UNITED STATES PATENT AND TRADEMARK OFFICE

Office Action Summary

10/801,041

DETAILED ACTION

Exhibit "A"

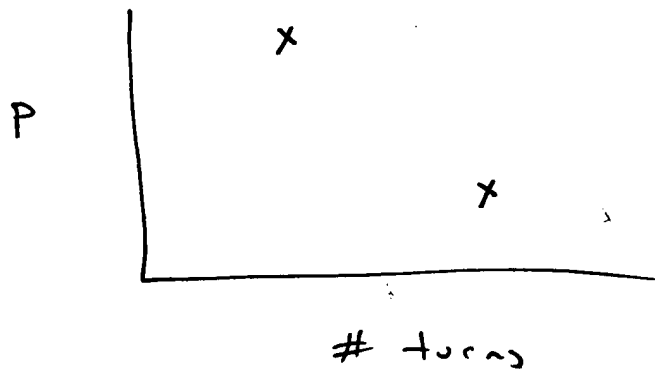
As to p. 5, regarding Claim 11; please look at Exhibit "A". While originally filed Para 17 provides for two points having different values (top graph), that does not mean that there is only an inversely proportional relationship (second graph from top). After all, the top graph may suggest a proportional relation (third graph from top), or something else (bottom graph). The top graph simply provides for two points, and therefore does not provide for the inversely relation now claimed.)

Applicant
has support
based on
para 17 for
two points \Rightarrow

claim 11 filed
11/12/05 calls for
inverse proportional
relation \Rightarrow
